M28 CORK TO RINGASKIDDY PROJECT

REPORT OF TRAFFIC AND TRANSPORTATION CONSULTANT
[ISSUE 01, MAY 2018]

Figure 4.1: Alternative Corridor Options

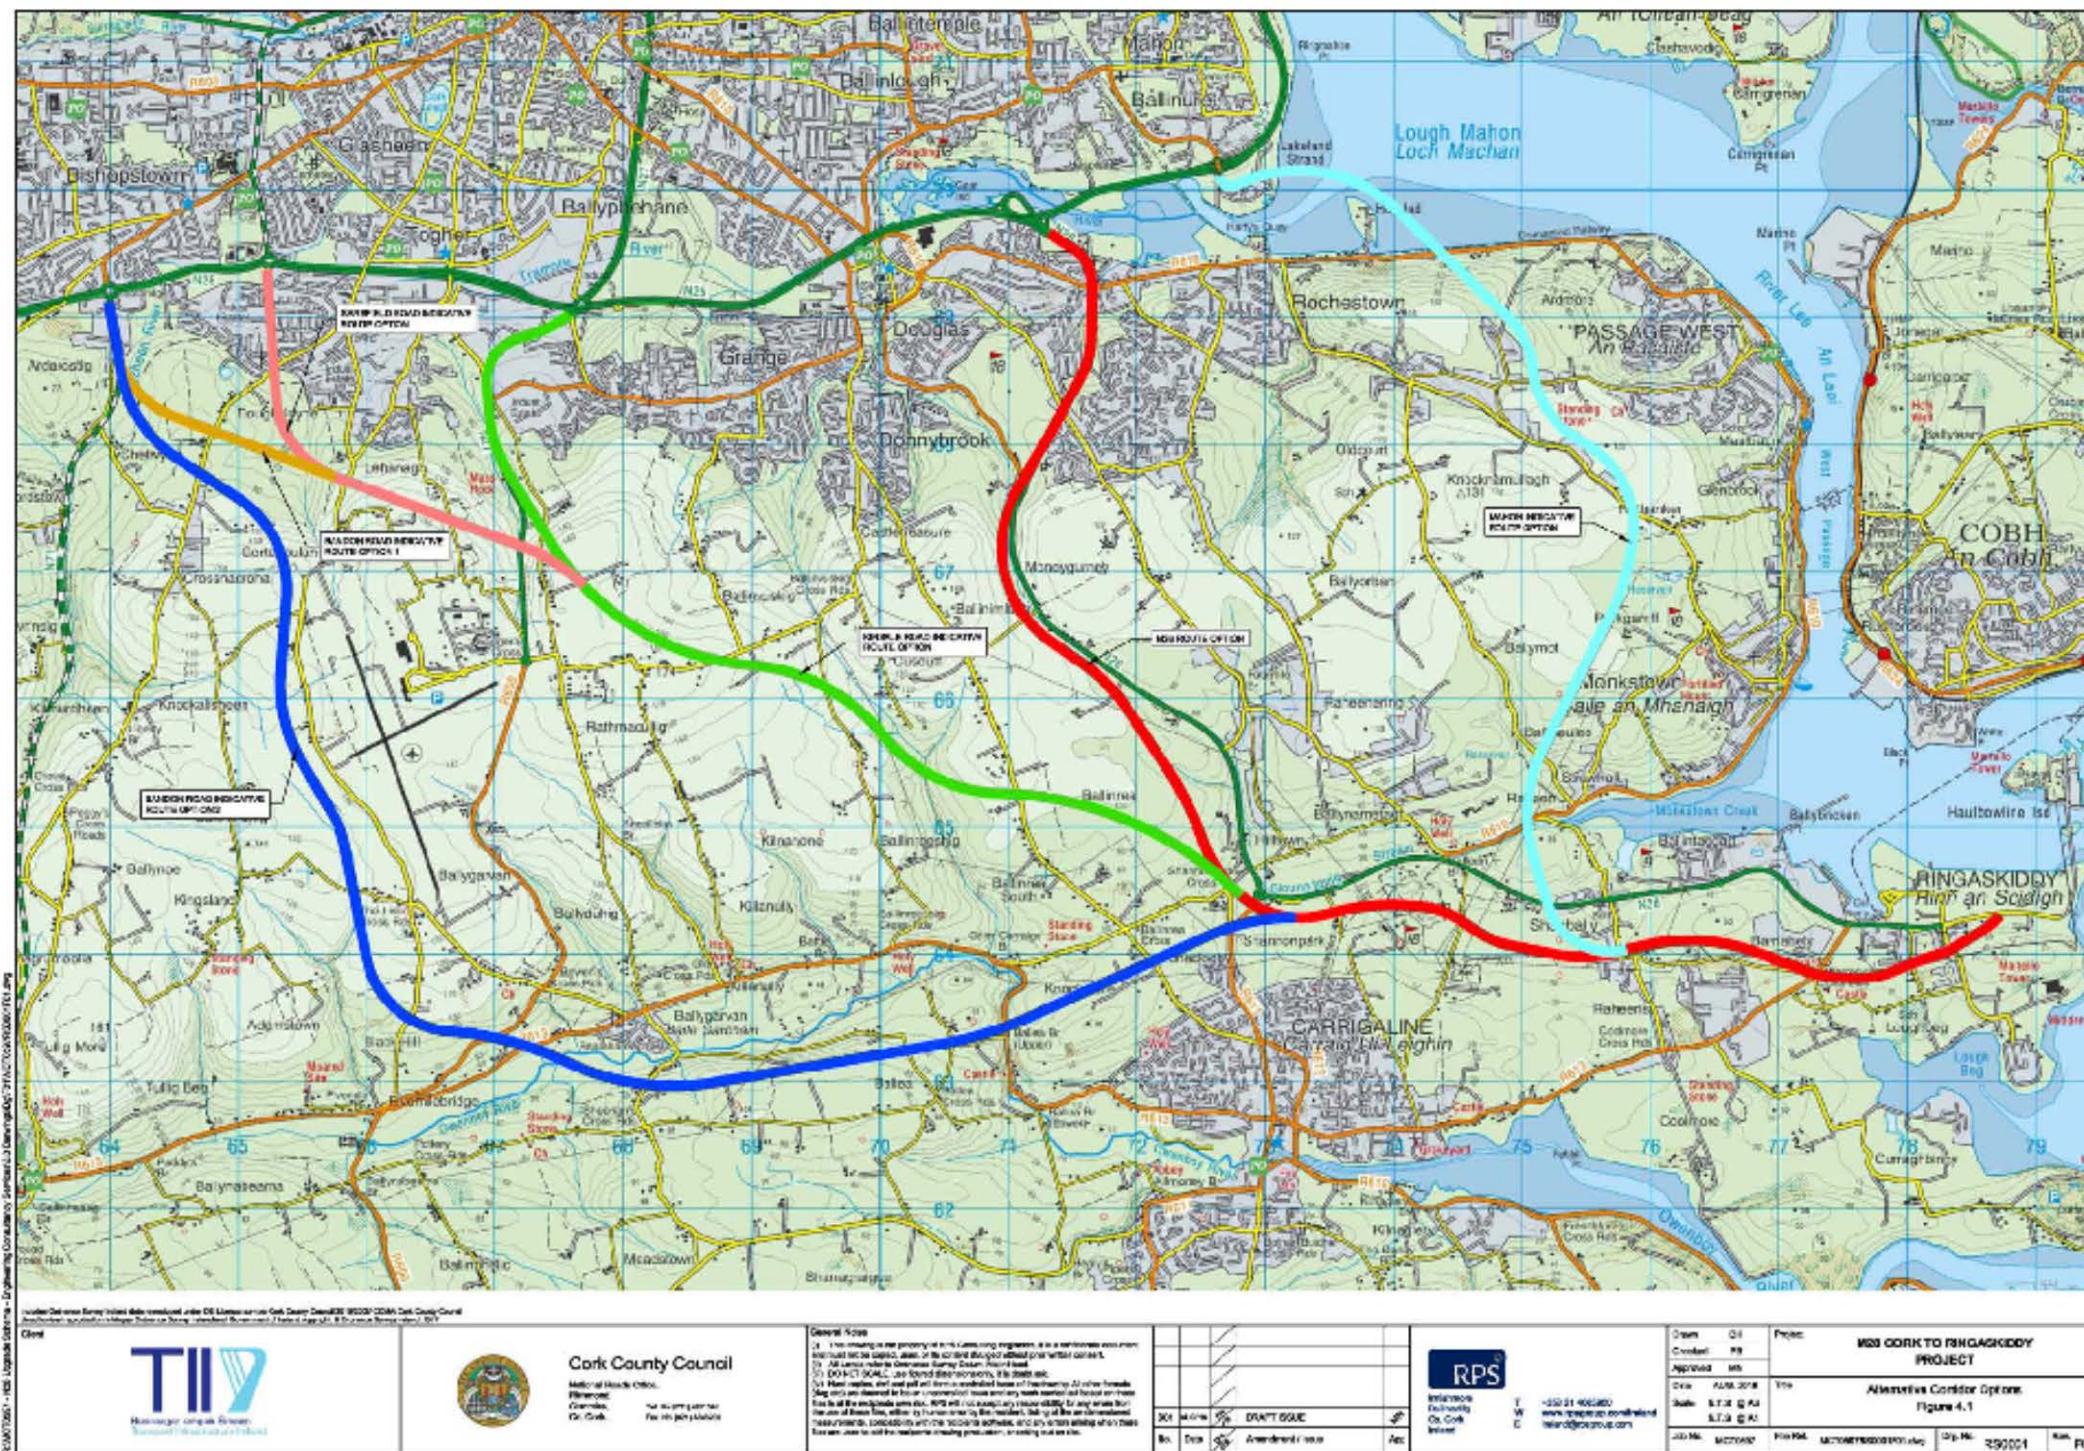
Options (ii), (iii), (iv) and (v) provide the desirable outcome of rerouting the Ten-T corridor away from the residential areas at the northern end of the existing N28 corridor.

The key economic objectives of the Scheme are to serve and support the development of the Port facilities and the economic development of strategically zoned lands at Ringaskiddy. While both of the western options, i.e. Options (ii) and (iii), would provide a motorway standard road between Ringaskiddy and the N40, the existing N28 would remain the most direct route to and from the N40 and Dunkettle Interchange. As a result, for both of the western options, approximately 50% of traffic generated by the Port, by strategically zoned lands and in Carrigaline would continue to use the existing N28. The western options would thus only partially achieve the key economic objectives of the Scheme. In contrast, the M28 Route Option would be the most direct route from Ringaskiddy and Carrigaline to the N40 and would attract most of the traffic generated in these areas.

The integration objective of the Project is to support the National Ports Policy and European TEN-T policy by creating a High-Quality Road from the Port at Ringaskiddy to the N40. However, because 50% of strategic traffic in the Ringaskiddy Peninsula would continue to use the existing N28 route, the western corridor options are much less effective in meeting this objective.

The M28 Route Option would remove all strategic traffic from the existing N28, thereby increasing the scope for inclusion of pedestrian and cyclist facilities on the existing N28 route. This scope would not be available for a scheme based on either of the western options

Figure 6.3.1 Cross-sections through the Scheme at Newyln Vale.

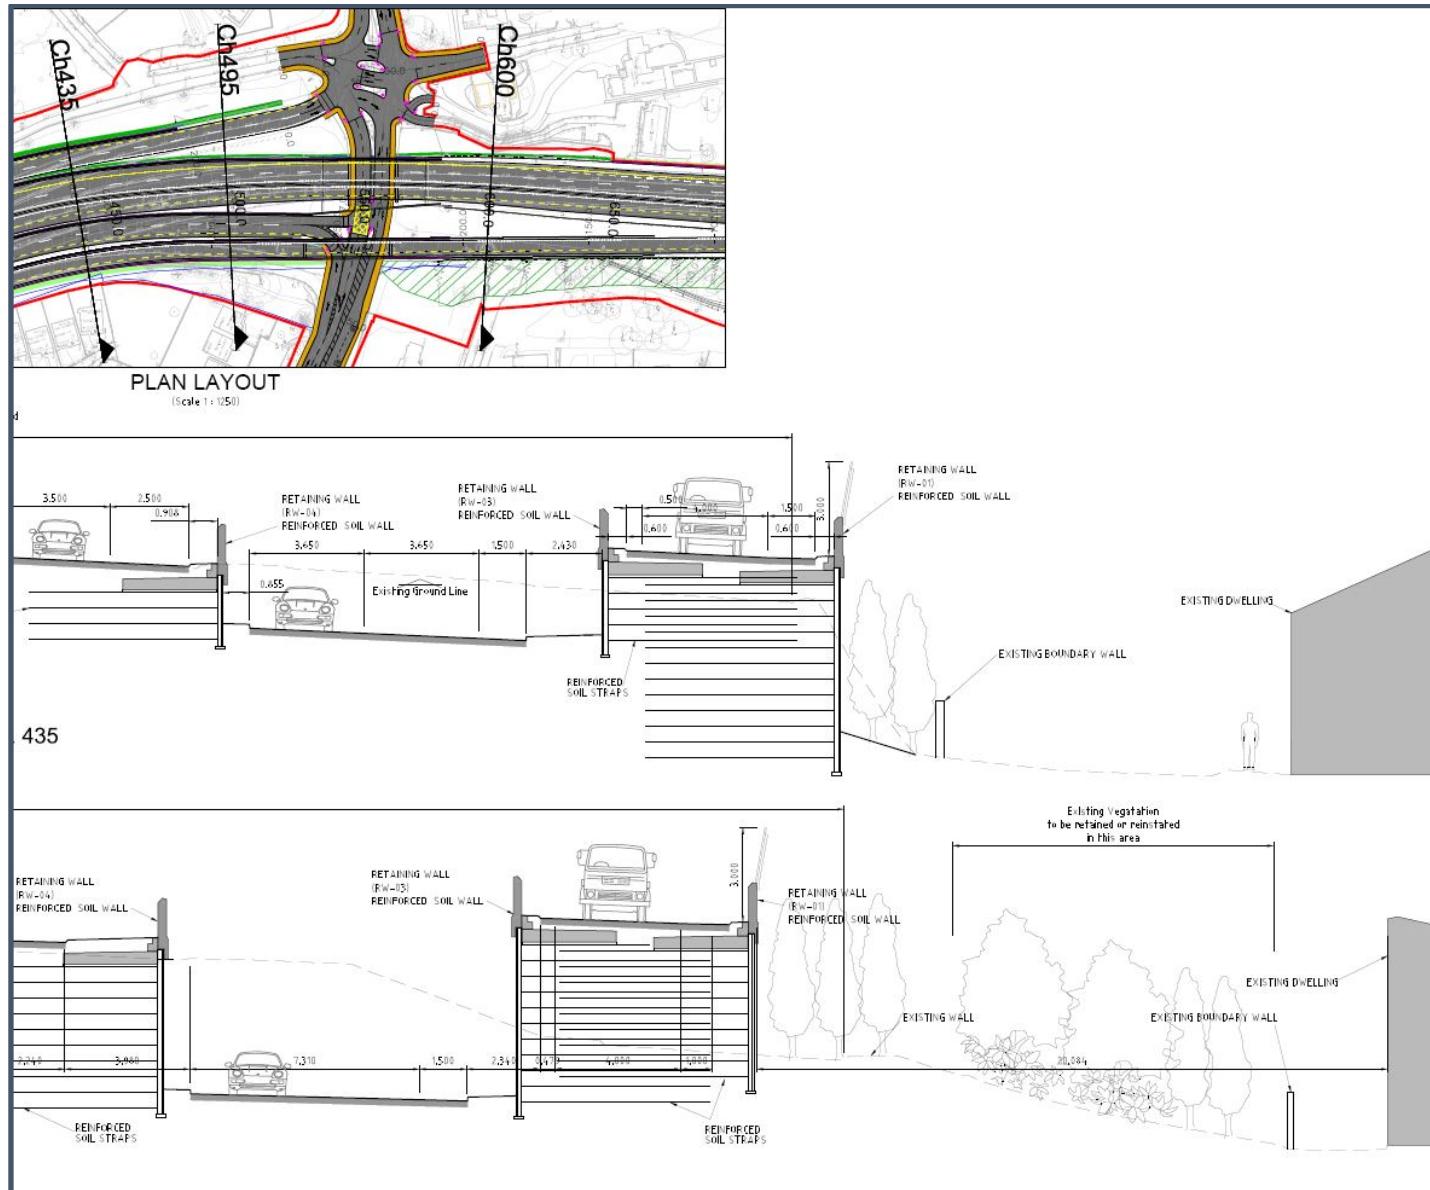
The Diverge Lane is closer to and higher than the existing N28 on either side of the Rochestown Road, at locations where it adjoins the Rochestown Rise, Newlyn Vale and Wainsfort residential estates. The EIS contains a series of drawings showing cross-sections at various locations through the Scheme. Figure 6.3.1 provides an extract from one of these drawings, Drawing No CS0102, which contains two cross-sections through the Scheme as it adjoins Newlyn Vale.

During the Oral Hearing, the author suggested that the Applicant give consideration to an alternative arrangement whereby the Diverge Lane is introduced as an auxiliary lane, thus eliminating the need for eastbound M28 traffic to cross into the fast lane. The Applicant undertook to do so and subsequently presented a revised proposal for the Diverge Lane, shown on Drg. No. SK5067 which is included in Annex I to this report. This revised proposal uses an auxiliary lane to introduce the as suggested by the author. The revision is achieved within the lands being acquired and with minimal impact. It is recommended that this alternative be incorporated into the Scheme.

Note that this revised proposal does not affect the line and level of the Diverge Lane where it adjoins Newlyn Vale.
